#### of federal Oil Pollution Act of Proposed regs to implement stricter 1990 laws

Volume 2.

No. 3/July 1992

# suggests changes to proposed

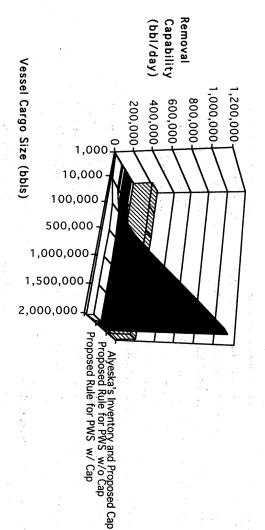
A table in the proposed rule sets caps on how much response equipment vessel owners and operators must contract for in advance, to ensure they are prepared for a worst case discharge of oil. The RCAC agrees with the concept of caps, but believes the caps are too low.

The caps are expressed in barrels per day, which translates into the equipment and manpower that must be contracted to be ready to respond for that vessel. It is important to remember that these are planning standards, not performance standards. For Prince William Sound, the RCAC recommends the cap be set no lower than 200,000 barrels

mends the cap be set no lower than 200,000 barrels per day for TAPS trade crude oil tankers. Caps for all other waters nationwide should be doubled.

This graph shows the effect of the cap on required recovery capability for yessels operating in Prince William Sound. Alyeska's current inventory is enough to recover 225,000 barrels a day. The proposed rule, without the cap, would require recovery capability of more than 1.5 million barrels a day. The cap reduces the requirement to 70,000 barrels a day. "Tier 3" refers to the response resources the plan must provide to be on-scene within 36 hours of notification that
